# North Dakota Department of Transportation

## ADDENDUM 2 – JOB 25

TO: All prospective bidders on project SOIB-5-094(088)061, Job No. 25 scheduled for the May 13, 2016 bid opening.

Sheet 20-7:

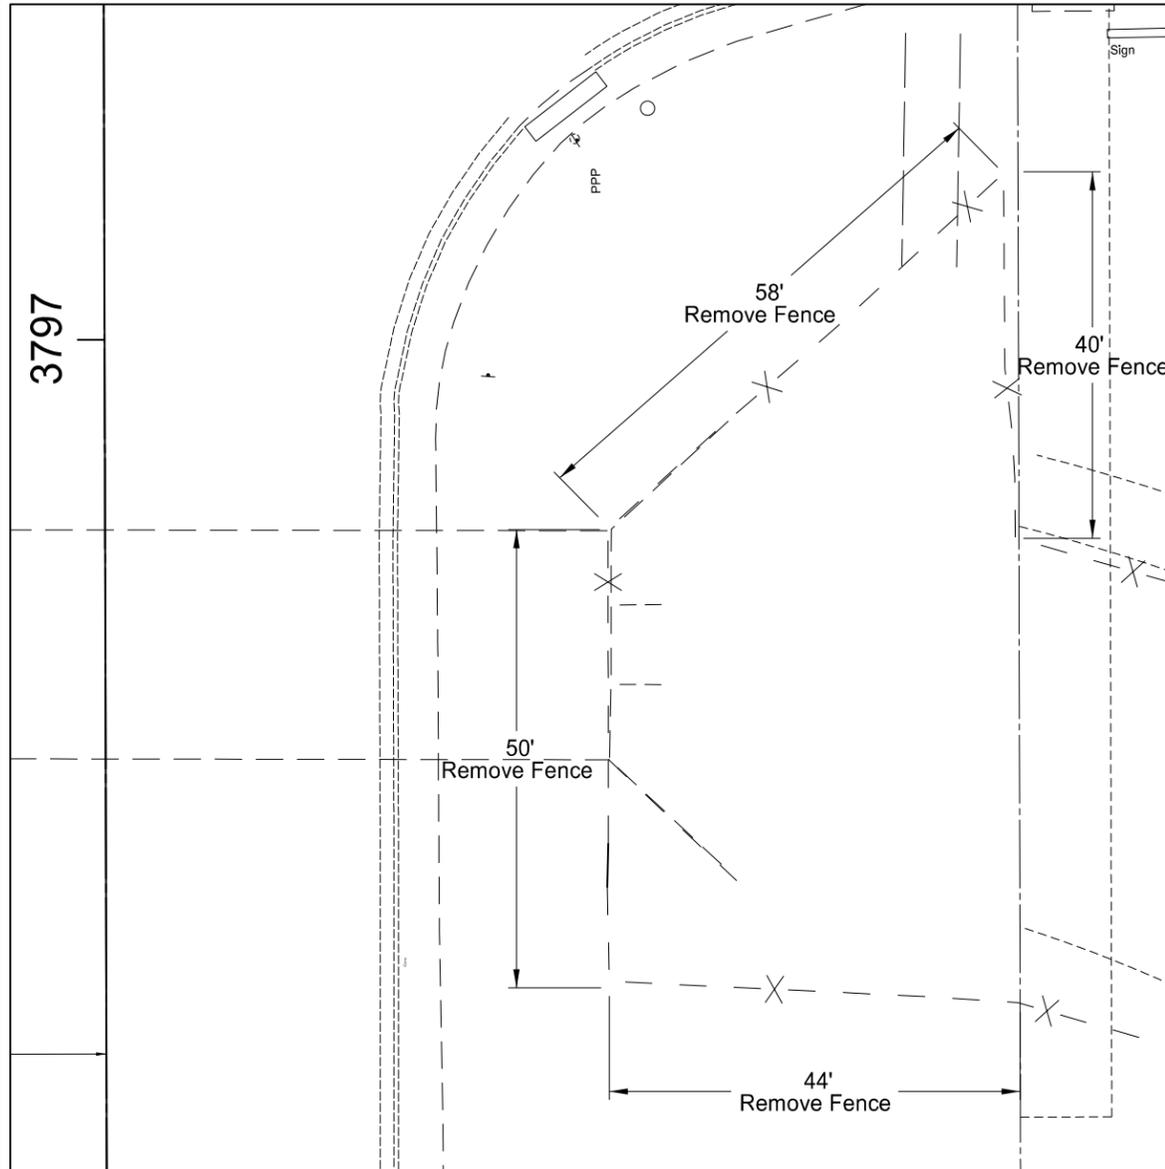
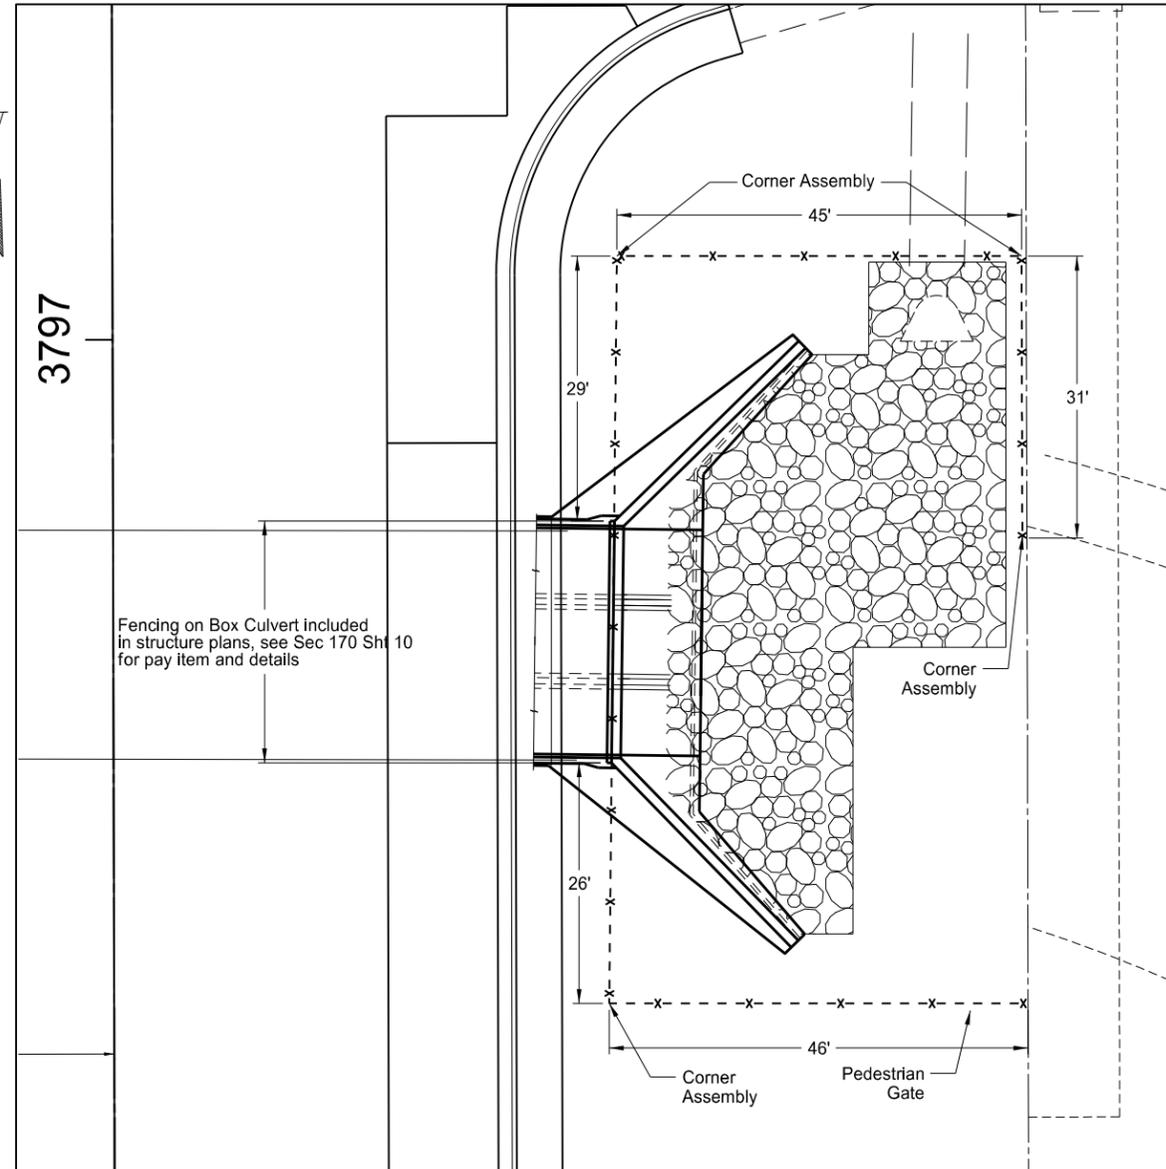
Added notes requiring a top rail and specifying the height of the fence.

**Note:**  
The fencing should be constructed in accordance with Standard Drawing D-752-2 with the following exceptions:  
1. The fencing should include a top rail. All equipment, materials, and labor required to place the top rail should be included in the price bid for " Fence Chain Link".  
2. The height of the fence and fabric will be 5'.
